STATE OF CALIFORNIA	Job Stamp	7-day Const. Calendar	Day No. 596
DEPARTMENT OF TRANSPORTATION	SFOBB SAS	Project Work Day No.	Day No. 796
Form HC-10A (Rev. 6/80)	04-0120F4	Date	07/31/2008

ASSISTANT RESIDENT ENGINEER'S

REQUEST FOR INFORMATION (RFI)

Subject: W2 Rebar in Void Ceiling	
References: Attached sheet 481R1 of 1204, Attached sheet Alternate Rebar Detail in Void Ceiling	
Sub/Sup: ABF	Sub RFI #:
Response Required by: 31-July-2008	Response affects critical path activity? Yes

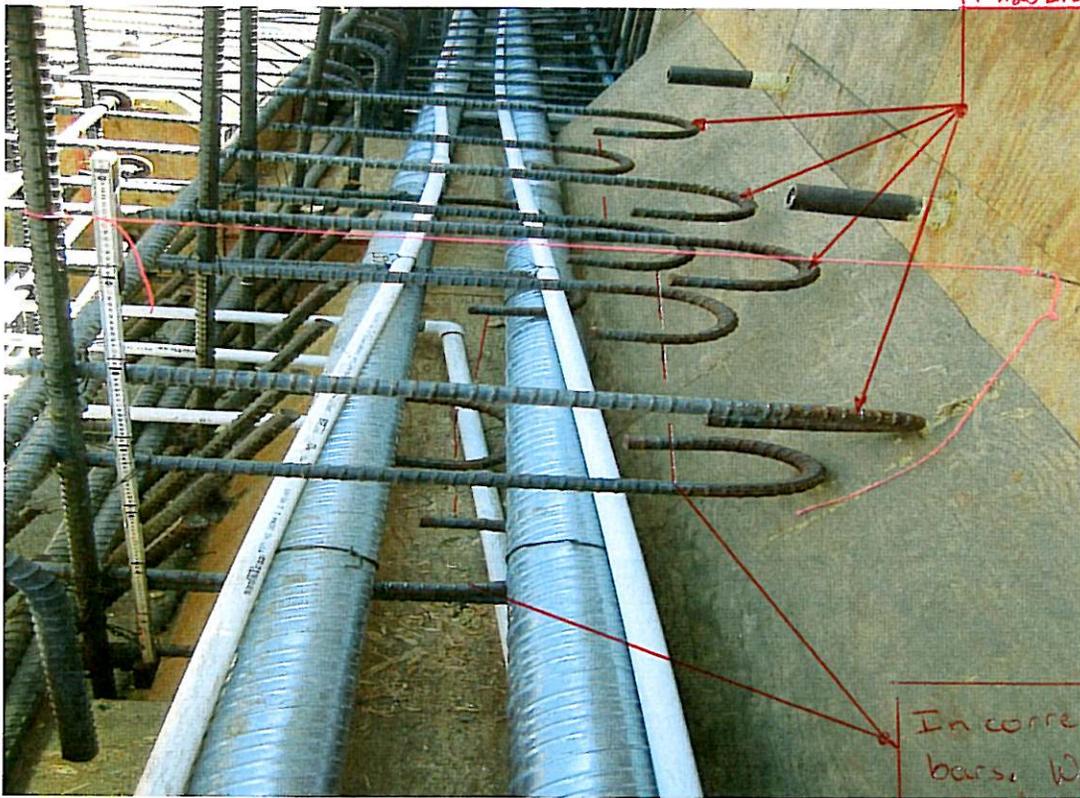
- Received email from R. Matin development length of 406mm for #25L5L0x, sheet 478R1 is 406mm (not 800mm as before).
- RSC previously placed #25L4L7 bars at the wrong elevation (see photo below). I discussed this issue with B. Bedwell and together we discussed with B. Bognaes. During our discussion B. Bognaes began to yell at me I asked him to stop he then through his hands in the air and requested T. Greenlee discuss

issue with us and join us to visually look at the bars. T. Greenlee agreed to add 4-#25L4L7 at new location so that to hook vertical form saver at vertical west face (see sheet 478R1).

4-#25L4L7 @ ~ correct elevation

In correctly placed #25L4L7's/46 bars. Will remain but cut candy canes back

4-#25L4L7 at new location to row of horizontal bars so that to hook vertical form saver at vertical west face (see sheet 478R1).

#12 CAP BEAM REINFORCEMENT DETAILS NO. 8

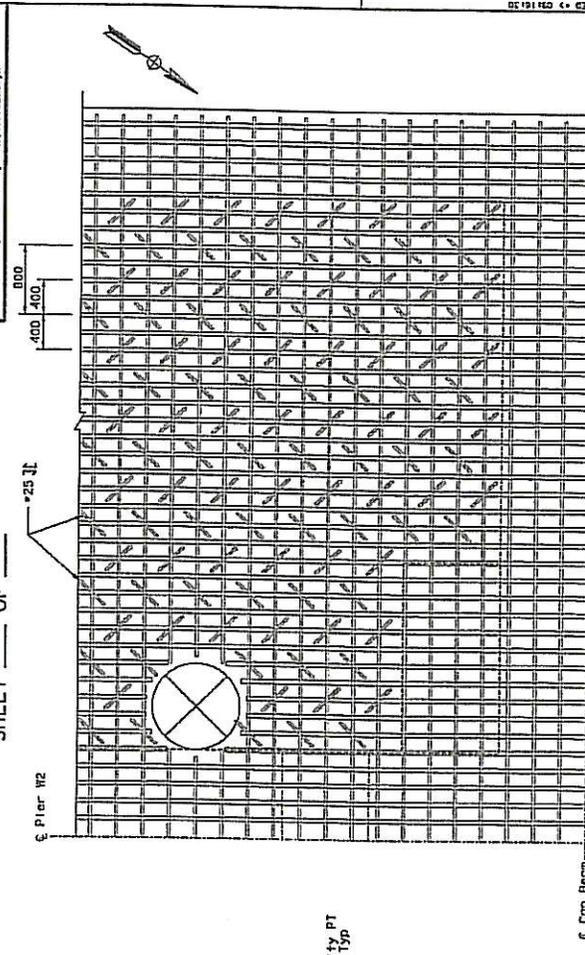
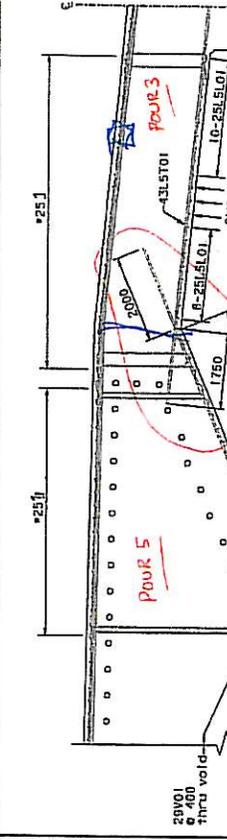
Per WDC discussion, ABFJV proposes altering the #43 rebar layout shown on Sheet 481R1 Section F-F and Section G-G to what is shown on the attached sheet "Alternate Rebar Detail in Void Ceiling". Shown on sheet 481R1, the #43 rebar in the void ceiling cross at the grade break at an angle protruding 2000 mm beyond the point of intersection. ABFJV proposes moving the intersection of the bars outside of Pour 3 and into Pours 4 and 5 for the South and North ends of W2, respectively. This change will substantially decrease the quantity of reinforcement that needs to be placed to complete Pour 3 and will simplify the joining of the #43 bars within these Pours.
